08/01/06

Inspection Report of 5305 SE Jennings Lane Stuart Fl 34997 Prepared for James & Teresa Dooner

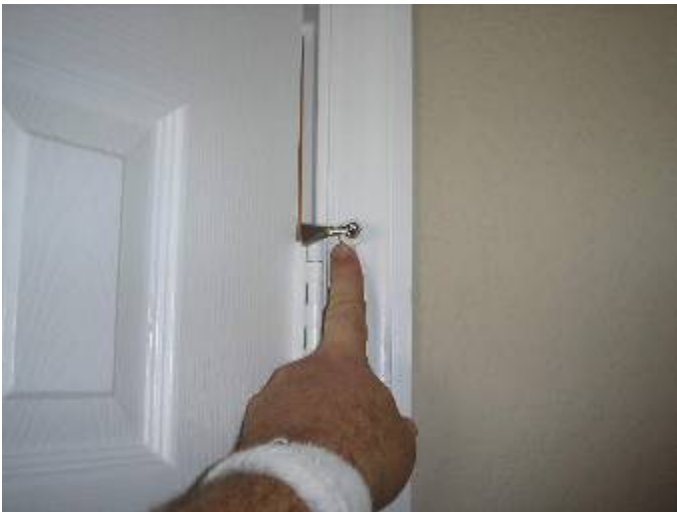
The drywall is not finished & the carpet is not correctly secured in the master bedroom closet.

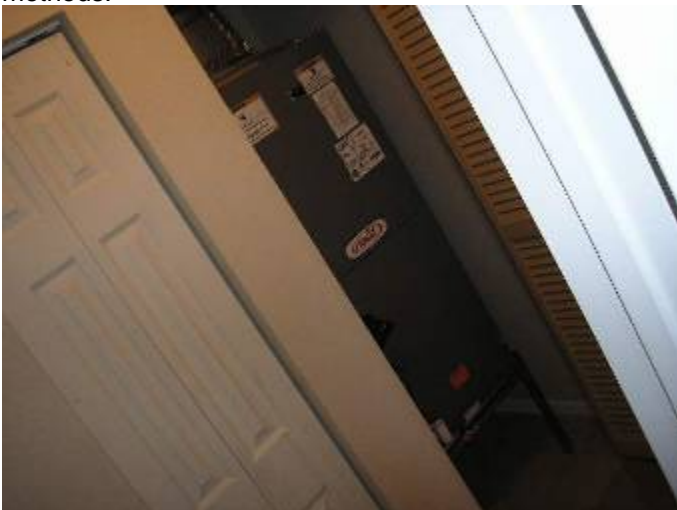
Some of the drywall was not painted or correctly finished inside the AC mechanical closet.

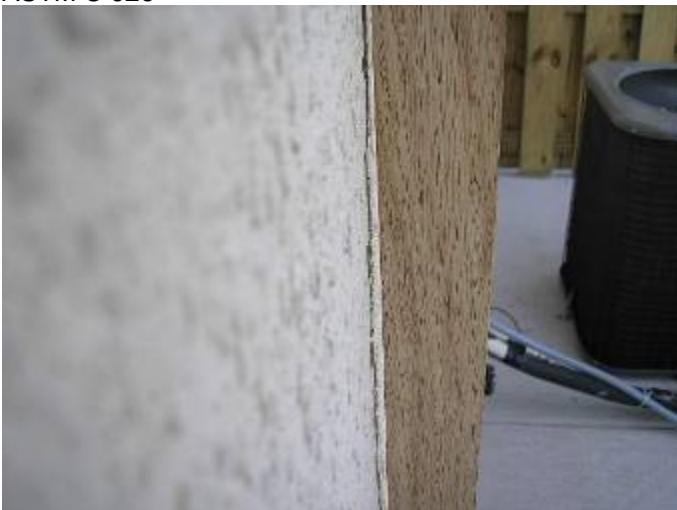
Some of the stucco work appears to be uneven, curved in/concave & not the proper depth. ASTM C 926, §2504.2 §1403.1.3

The stucco at some at the walls is concave or curved in & does not appear to be the correct thickness. §2509.1.1, ASTM C 926

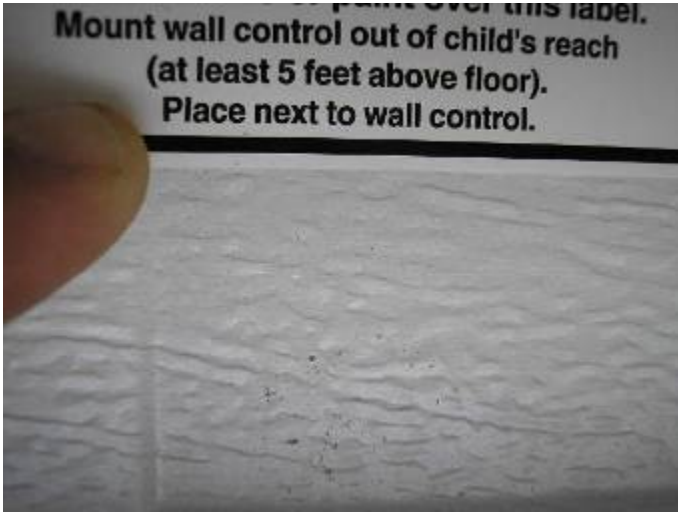
The ornamental trim is not completely sealed at the exterior wall to prevent water & pest intrusion. FBC §13-606.1.ABC.1.2

The drywall is not correctly sealed around the sprinkler system piping at the garage ceiling.
